VERMONT YANKEE NUCLEAR POWER STATION

AMENDMENT TO FACILITY OPERATING LICENSE

Amendment No. 28  
License No. DPR-28

ENVIRONMENTAL IMPACT APPRAISAL  
BY THE OFFICE OF NUCLEAR REACTOR REGULATION

Fig. 1 Temperature Increases in Vernon Pond as Calculated from Dye Concentrations at a River Flow of 1270 cfs.

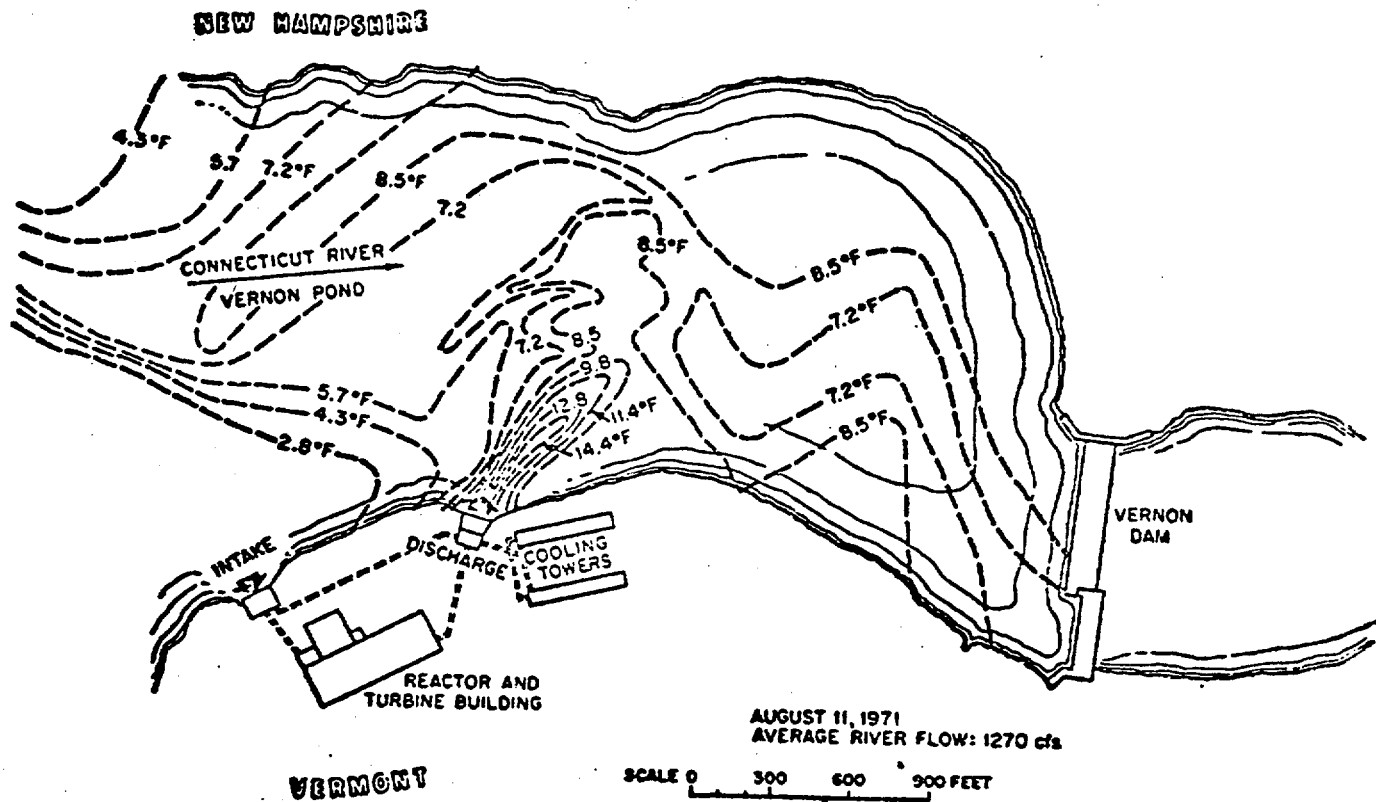
1. A simple energy budget on the control volume encompassing Vernon Pond, see Figure 1, can be formulated including heat input from the plant, heated water released from the dam, and heat transfer to the atmosphere. Such a balance clearly shows that water leaving Vernon Pond would have a temperature elevation of about 12<sup>0</sup>F as it was released from the dam, if the system were at steady state. The dye predictions seem to indicate that the water leaving the dam has a temperature elevation of about 8<sup>0</sup>F.

This difference in release temperatures is too great to be explained by the lack of precision of the control volume approach but may have been caused by one of the following reasons. If the release through Vernon Dam were held steady at 1270 CFS, but the flow from upstream were greater, the stage of Vernon Pond would increase, diluting the dye more than expected. This would account for the lower apparent temperature. Alternately, there is a strong indication that the dye experiment was not allowed to reach steady state at the flow rate of 1270 CFS. A

rough computation of the time to reach 99% of the steady state, based on steady flows through the control volume of Vernon Pond, gives a value on the order of 5 to 10 days. It was not apparent that the dye studies were run for this long. Hence, the dye concentration possibly did not build up to the steady state level.

2. Conditions of low flow in Vernon Pond are conducive to marked stratification. Therefore, dye tracer experiments with unheated effluent would not be expected to faithfully replicate the prototype conditions. Preliminary computations (subsequently discussed) based on the density difference between the expected temperature of water in Vernon Pond and cool upstream water indicate a strong thermal wedge extending well upstream from the discharge area even further than indicated by the dye study.
